Commision of the European Communities
Guyana Sea Defence Lome IV Project
Essequibo/West Demerara Locations

Investigation of slip failures at
Henrietta and Anna Regina

Delft Hydraulics
Delft Geotechnics

October 1996

Cross-section of Area B, section 119

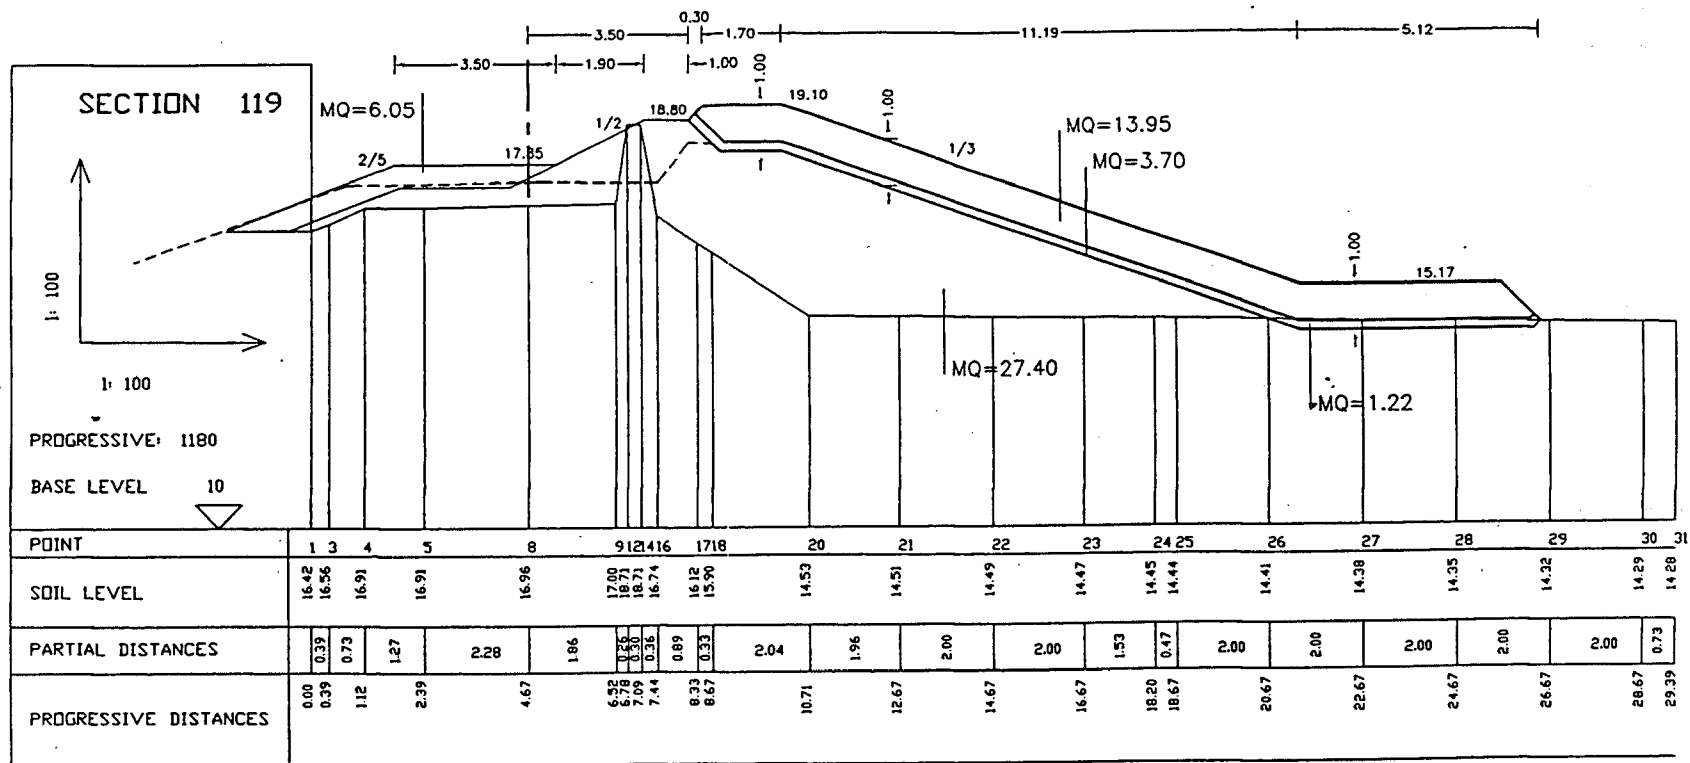
The plan view of all Areas (B, C, F, G and I) and cross-sections, both before and after construction are given by PAC/GELFI (1996). One of these cross-sections is given in Figure 2.1.1. The rehabilitation is built over the old structure where the existing seawall was demolished. Sand fill was used in order to make the outer slope of 1:3. A slip failure in general will happen if the load exceeds the bearing capacity. Therefore, the larger the load on the existing structure and foreshore, the more critical the cross-section is for slip failure. All cross-sections have to bear the filter layer and armour layer, which are similar in weight for all cross-sections. The only varying measure was the amount of sand fill. This amount of sand fill can give an idea about which cross-sections had to bear the largest loads and were, therefore, most critical for slip failures.

The amount of sand fill for each cross-section is given on the drawings. In Area B cross-section 119 (Figure 2.1.1), for example, it is 27.4 m³/m (MQ = 27.4). All cross-sections of all Areas were analyzed.

Plan view of area B from sections
60 - 145 with locations of slip failures

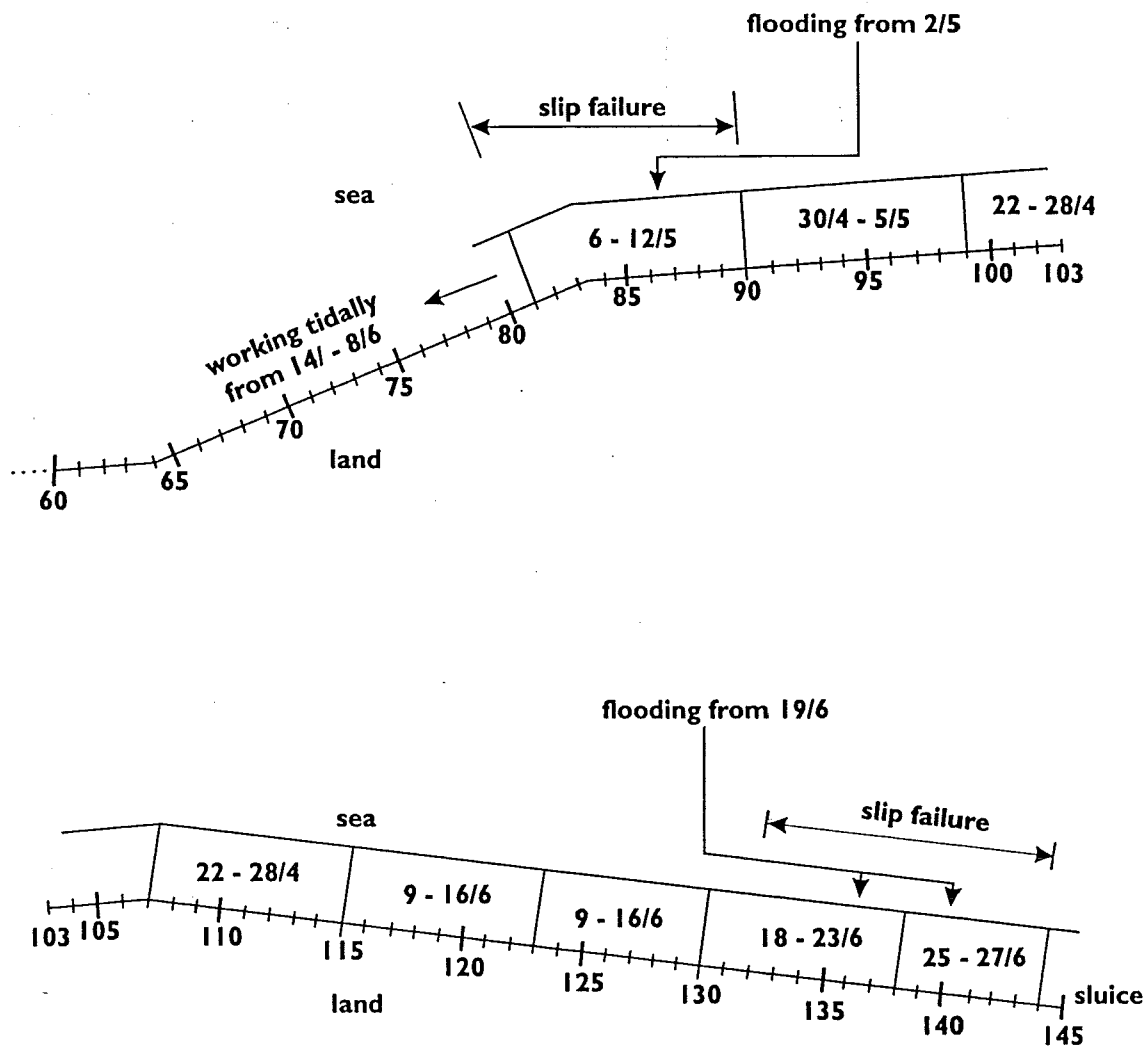
In Area B slip failures occurred on 2 June and 6 July 1996. A plan view of Area B with the location of cross-sections is given in Figure 2.1.2. The distance between the cross-sections is 10 m.

The slip failures occurred in Area B, sections 81-90 and 132-144, both within above areas of maximum sand fill and, therefore, maximum loading. The failed area is in total 210 m, where the other part with maximum loading of 320 m did not fail. With respect to loading more critical sections were present than the failed areas. This means that also other sections could have failed, but as that did not happen other circumstances must have been present at the failed sections that caused these failures.

Location cofferdams and progress of work

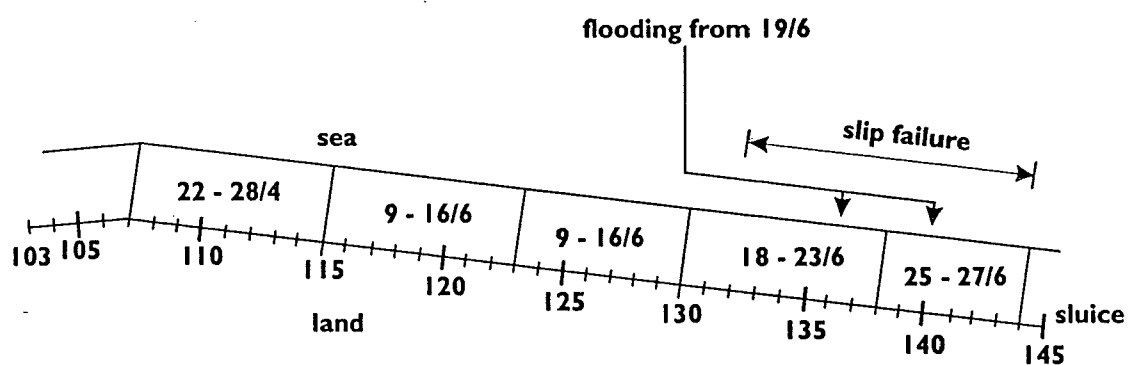
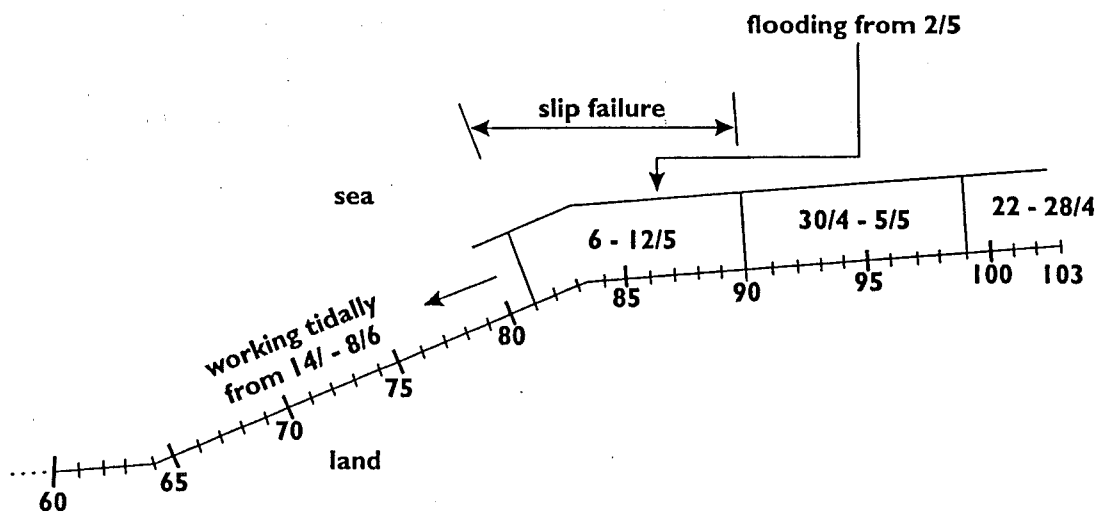
In SRKN's engineering/DSCL (files, Weekly progress reports from April 1995 till August 1996) the progress of execution of the works has been described. From these files the execution in Area B can be retrieved. First of all it should be noted that the period April - June gave extensive rainfall. Some areas along the river were flooded and the government declared these floodings as a national disaster. From the SRKN-files the following description of the execution of work in Area B can be made. The location of the cofferdams constructed by the contractor are shown on Figure 2.2.1.

- The slip failure areas coincide with the areas between the cofferdams. This leads to the conclusion that it is possible that the cofferdams had an effect on the occurrence of the slip failures. Specially if the first slip failure from sections 81-90 is considered. The section with a critical loading condition (see section 2.2.1) lies between 78 and 84, where the boundary of the slip failure is at section 81, exactly the location of the cofferdam.

FIG. 2.5.1

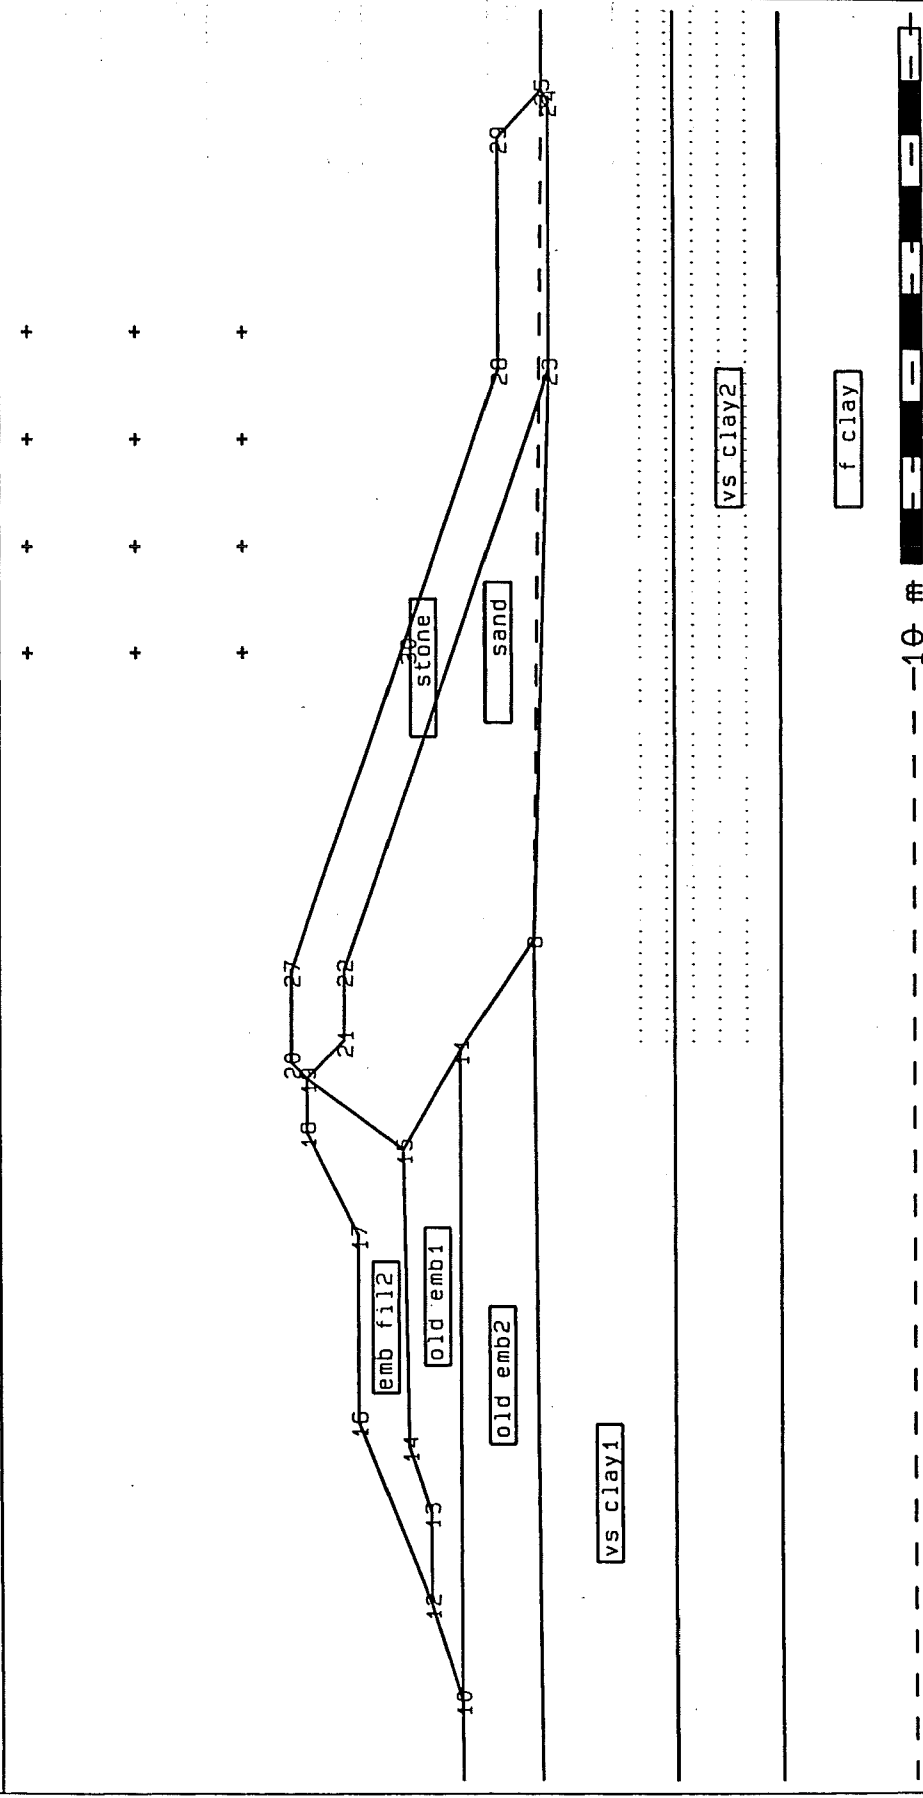
Figure 2.5.2 shows the soil parameters chosen for input in the computer programme. The calculation has been done using the undrained condition (total stress analysis) which enables determining the degree of stability of the sea defence (cross-section 117) at the moment before the failure. The most unfavourable loading condition, being the low tide period right after a high tide, has been analyzed.

The calculation method applied is the Modified Bishop method of slices (circular sliding planes). The computer programme used is MSTAB (Micro computer STABILITY), developed by Delft Geotechnics in co-operation with the Water Defences Department of the Ministry of Transport and Public Works of the Netherlands. The result of the total stress stability analysis is presented on the Figure 2.5.2. The sliding plane is given. The calculated minimum stability factor $F_{min} = 1.20$. This stability factor is considerably smaller than the value 1.68 mentioned in the report (GSEC, 1995-2).

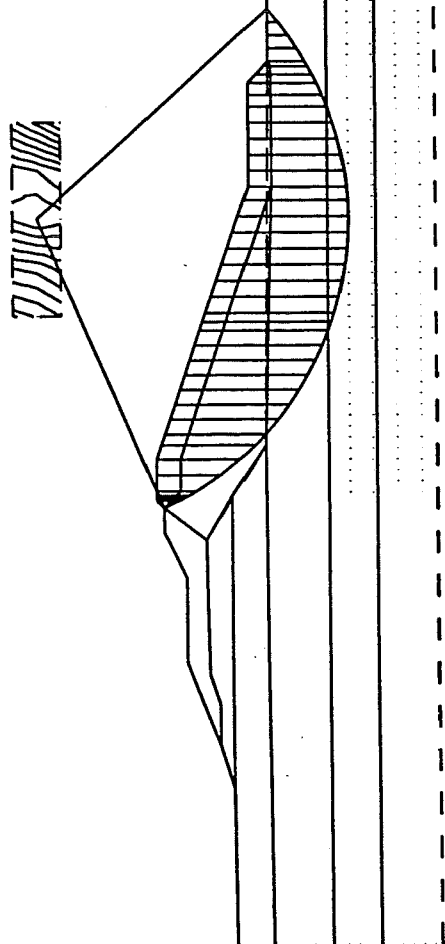
In order to determine the effect of the much lower shear strengths measured near the seaside toe in the Henrietta site after the failure, the calculation has been done applying the lower C_u -values, measured in the soft clay layers near this toe. The corrected C_u values decreased to 12 kPa in the very soft clay, see the table in Figure 2.5.3. The result is that the minimum stability factor decreased to 0.62, which means slip failure.

FIG. 2.5.4

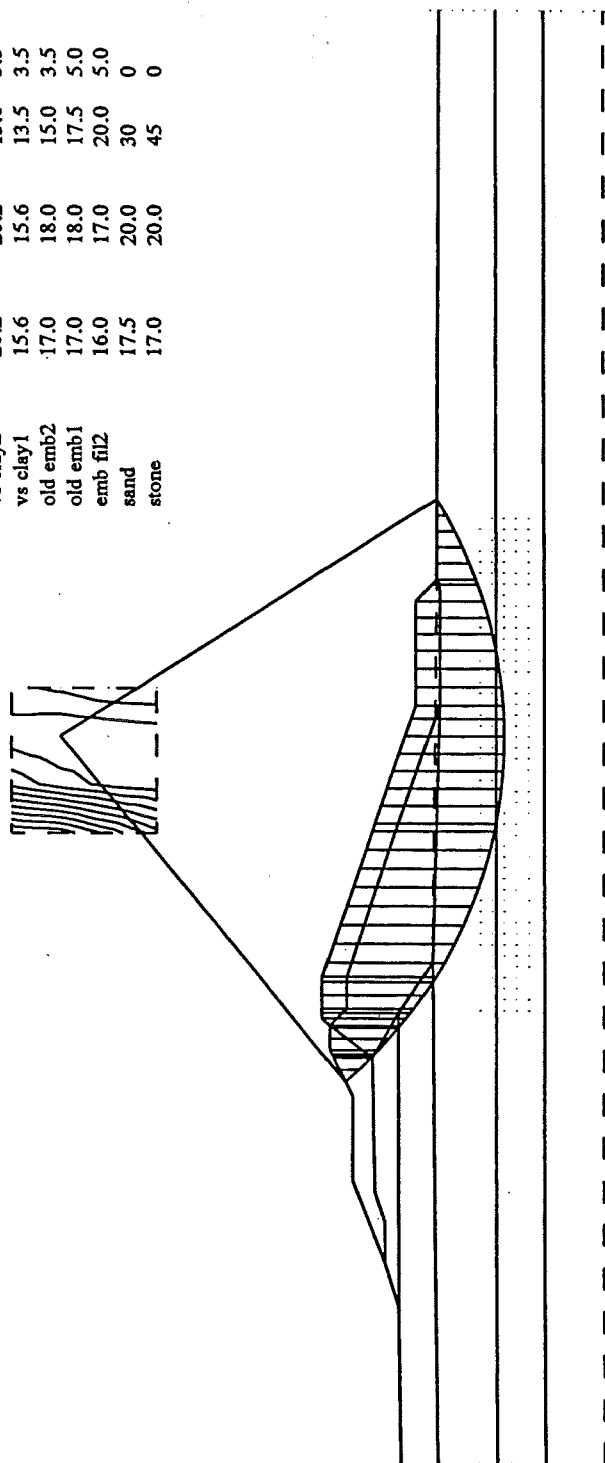
The result of the effective stress stability analysis is presented on the Figure 2.5.4. The sliding plane is given. The calculated minimum stability factor $F_{min} = 0.95$. This stability factor indicates that at the 7th of July 1996 at low tide the sea defence at the Henrietta site was unstable.

Questions about the value of the soil investigation results, both before and after the failure, will remain. But based on these values one can conclude from the above mentioned calculation results, that the degree of stability of the critical cross-sections in Area B during construction was close to 1.0. The calculation with the low values obtained from the soil investigations after the Henrietta slip failure shows clearly that weaker soil can lead to slip failure. And the probability of occurrence of such a slip failure was increased by the removal of the sheet piles by vibration.

FIG. 2.5.5

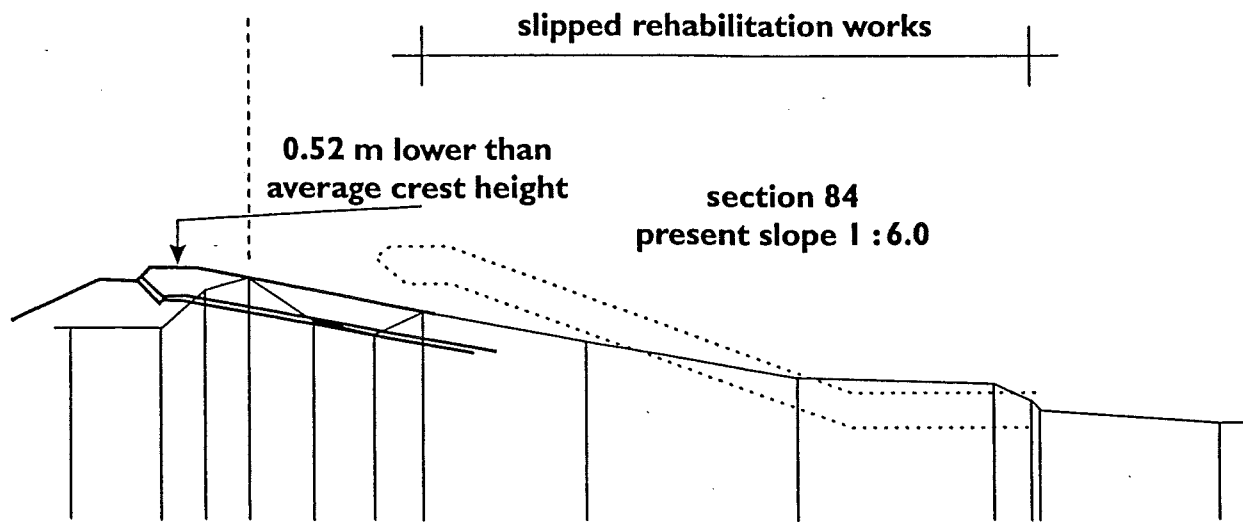
The settlement calculation model is based on the same cross-section 117 and the input for the layer structure (the settlement model) and soil parameters was copied from the input for the stability calculations. The settlement parameters have been taken from the laboratory test results of the samples taken from boring 1B2 (GSEC, 1995-1). The settlement parameters are given in Figure 2.5.5.

In order to be able to predict the settlements of the complete embankment a number of verticals were chosen. In each vertical the total settlement was calculated. The calculation method is the Bjerrum method, described in the Dutch Geotechnical Standard (NEN 6744). The computer programme used is MZET, (Micro computer ZETting = settlement), developed by Delft Geotechnics in co-operation with the Water Defences Department of the Ministry of Transport and Public Works of the Netherlands. The sea defence profile including the respective layers is presented in Figure 2.5.5.

The results show that the theoretical end (99%) of consolidation is after 26 months. From the results it can also be derived that at cross section 117, at this moment mid-October 1996, a little bit more than 50% of the total settlement will have occurred. About 75-80% will have occurred after one year. In view of the above mentioned total settlement of 0.6-0.8 m this means, that the crest at the inner edge of the rip rap protection will have settled about 0.3-0.4 m and will, after mid-October 1996, still settle in the order of another 0.3-0.4 m.

Proposed permanent repair works at sections
84 and 89 Area B

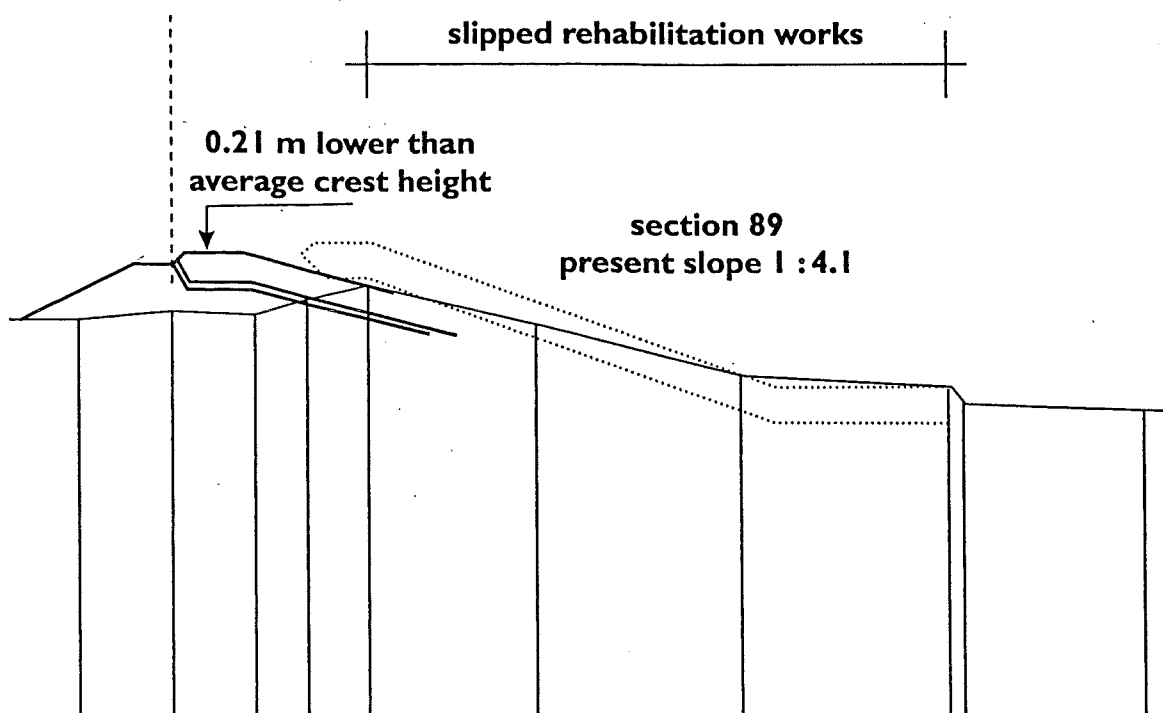
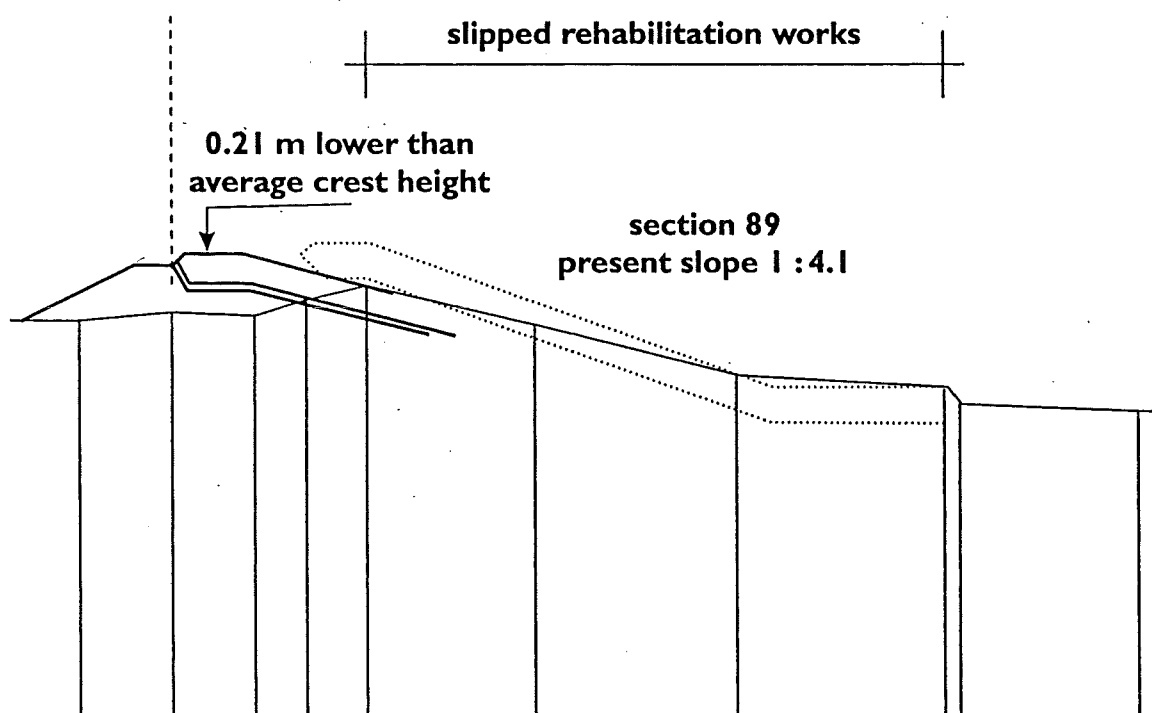
Figure 4.1.1 gives the measured profiles of sections 84 and 89 (SRKN'gineering/DSCL, 21 June 1996). Section 84 is in the middle of the Henrietta slip failure and section 89 is close to the side. The average slope in section 84 is now 1:6.0 and in section 89 1:4.1. This is much more gentle than the original design of 1:3. A gentle slope gives less wave run-up than a steep slope. It is therefore possible to make a lower sea defence than in the original design.

11. Permanent measures are fairly easy to perform. It is proposed *not* to reconstruct the slipped areas according to the original design, but to leave the slope as it is and to extend slope up to a sufficient crest level by applying the present inclination. This crest level can be lower than the original crest level as a gentler slope has less wave runup. The proposed measures are described in Section 4.2.
